BID NO.: 2018-21  
RELEASE DATE: March 27, 2018

**INVITATION TO BID TITLE: Partial Roof  
Replacement M.K. Rawlings Elementary School**

# PARTIAL ROOF REPLACEMENT AT: M.K. RAWLINGS ELEMENTARY SCHOOL

NO.  
**1.11**

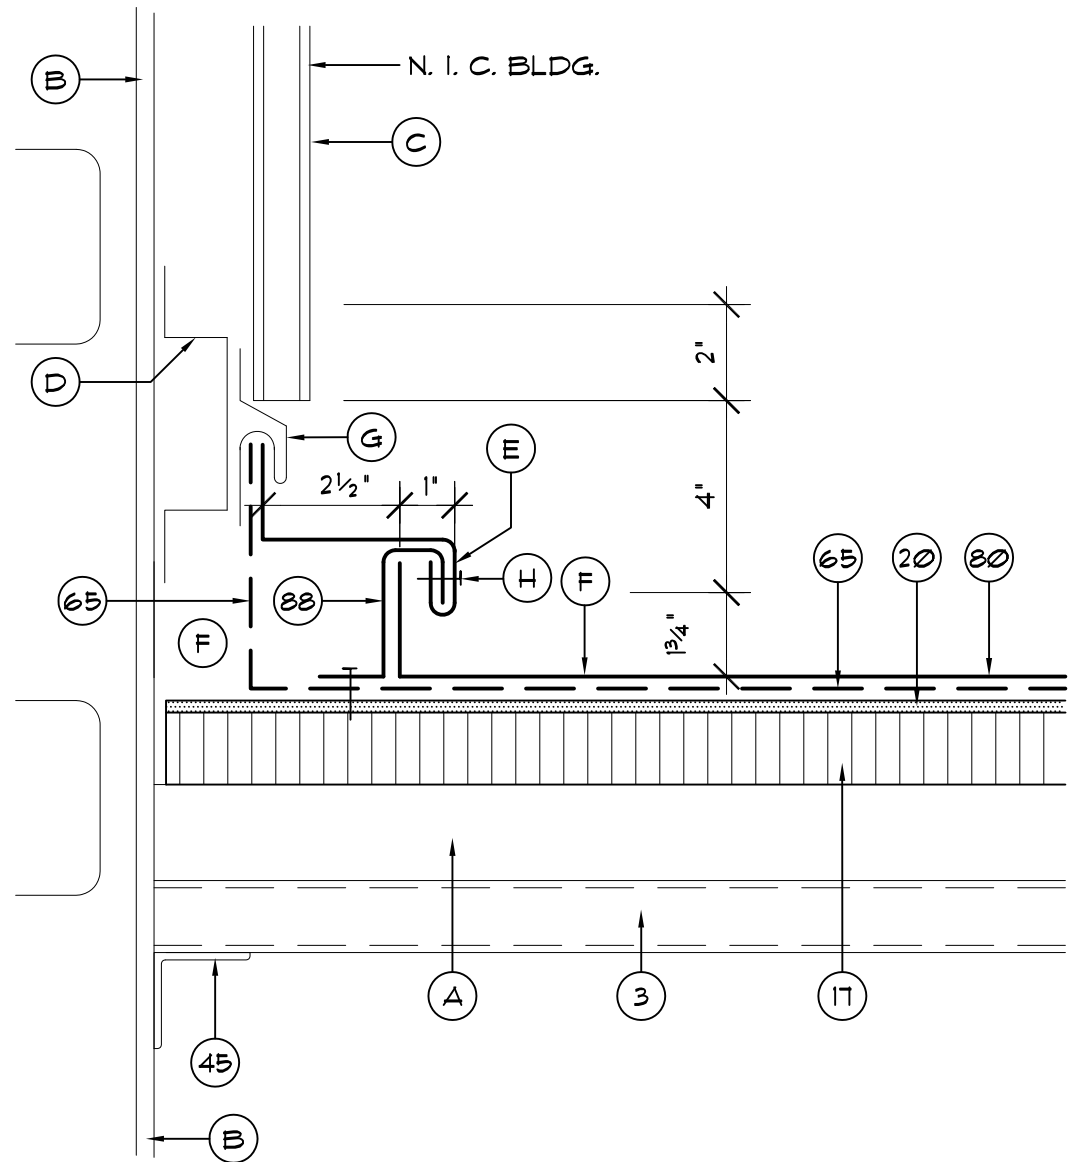
Add. 1.16: Detail 1.11 - Prefinished Aluminum Walkway Fascia Cover: DELETE this detail entirely due to a change in the scope of work

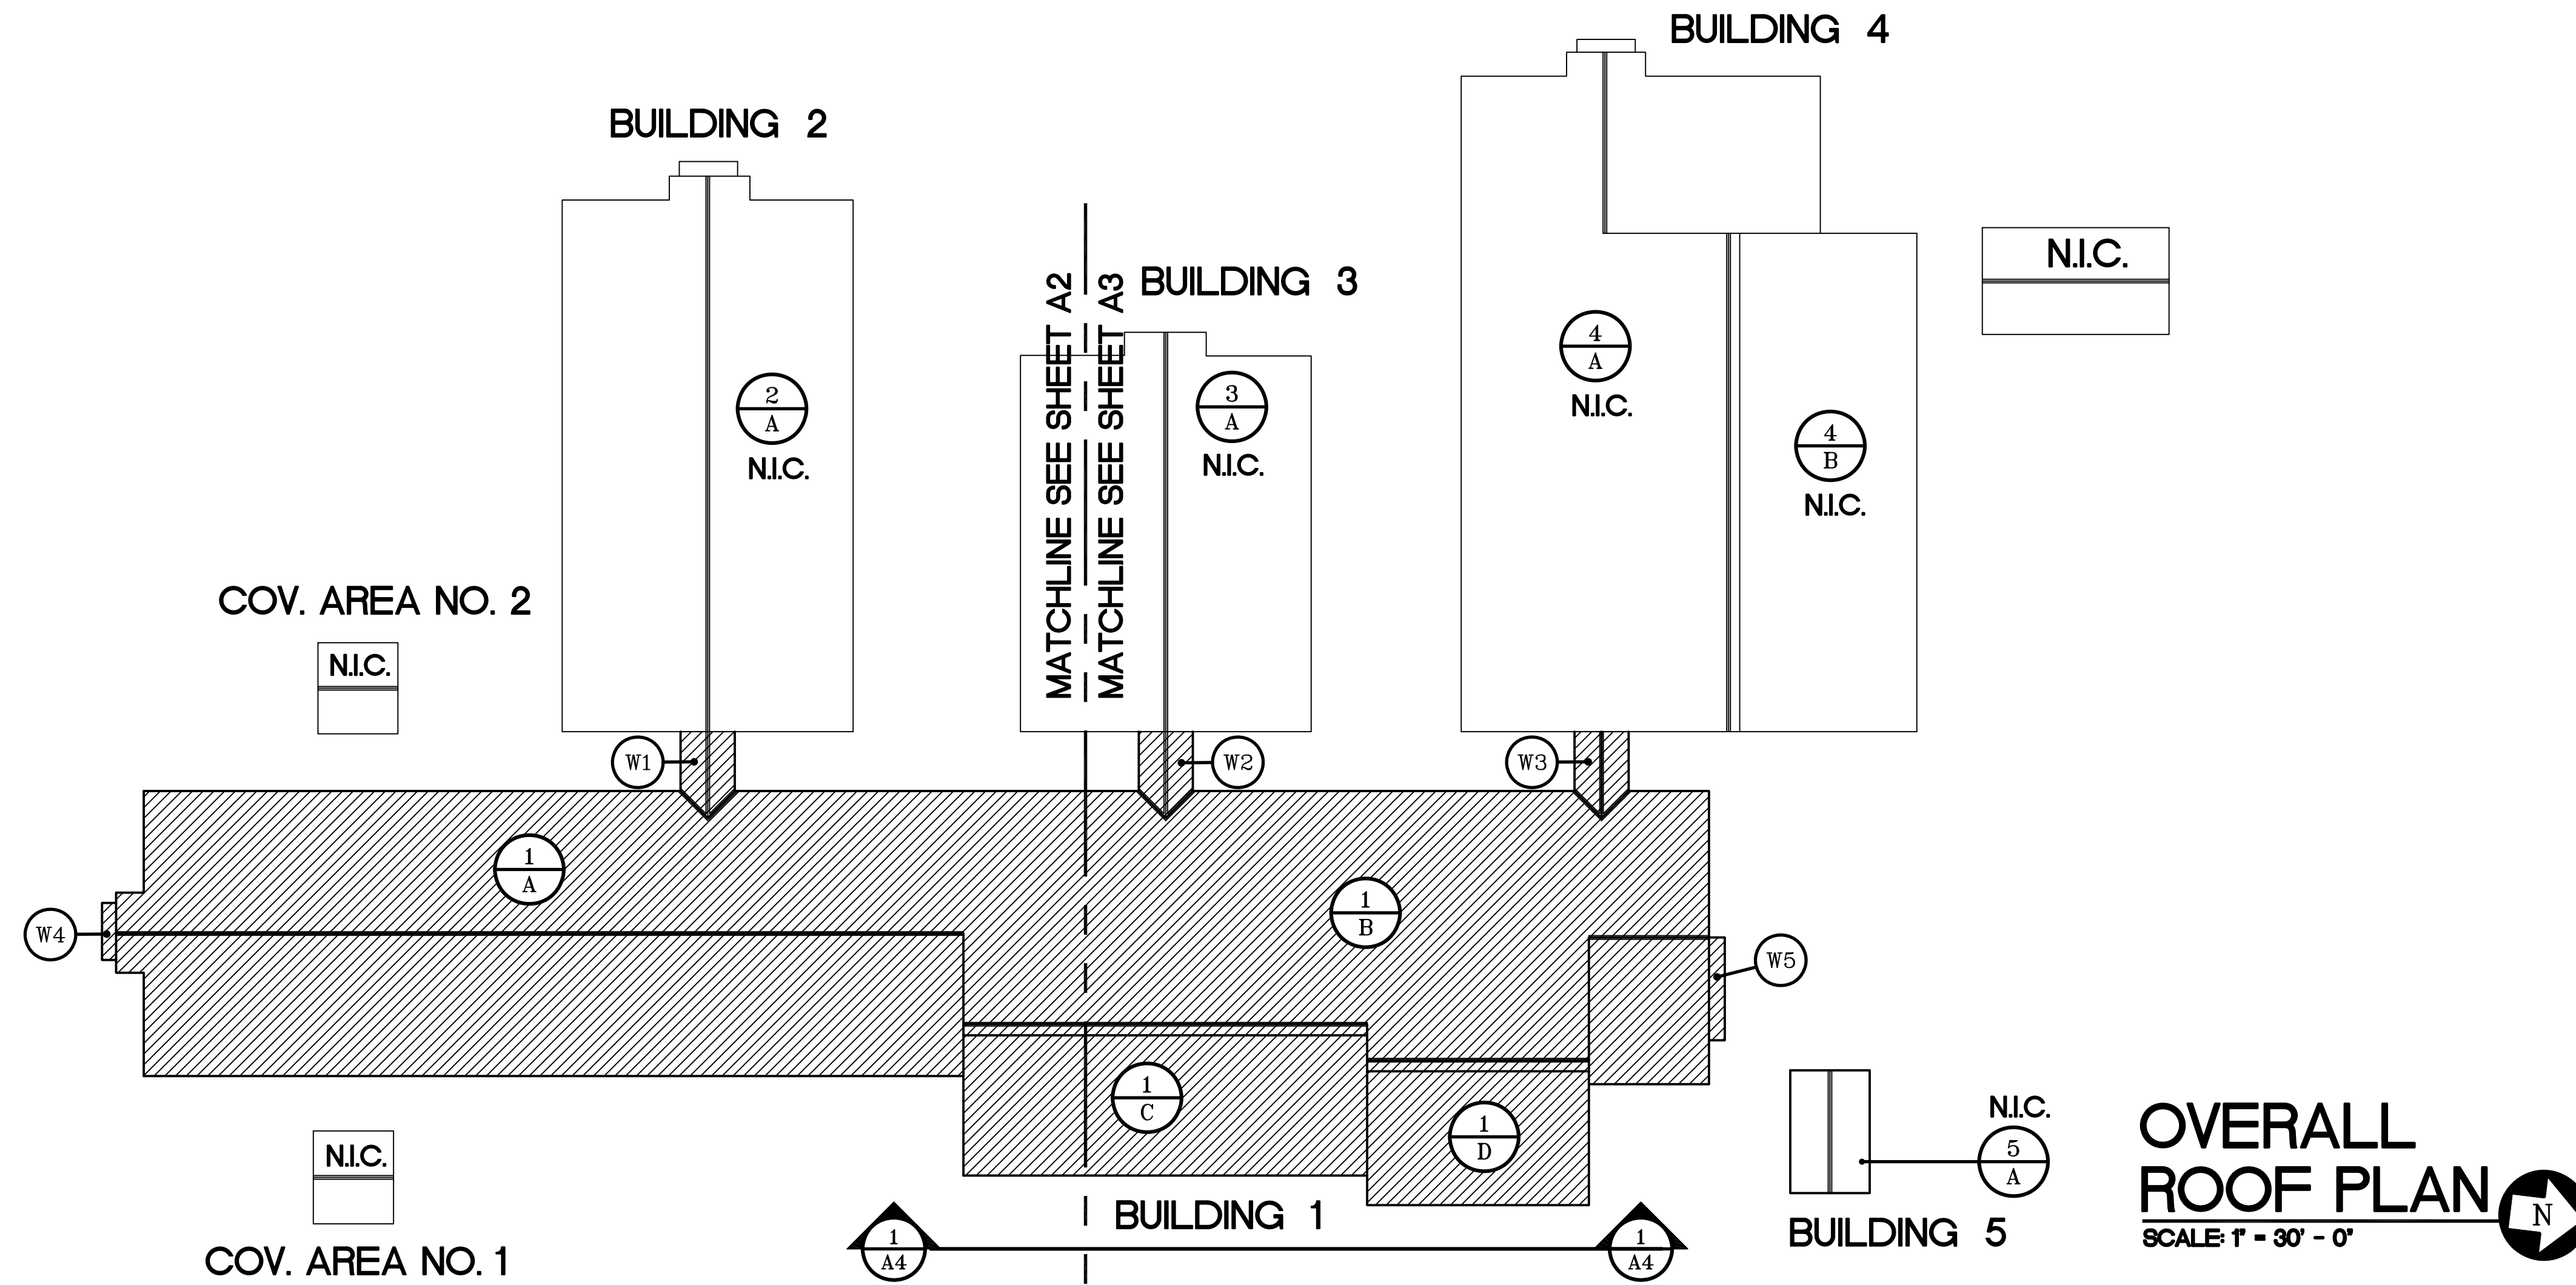
Add. 1.12: Drawing A1 – Overall Roof Plan: REVISE this plan to indicate that Building 5 is to be included into the Base Bid scope of work of this project.
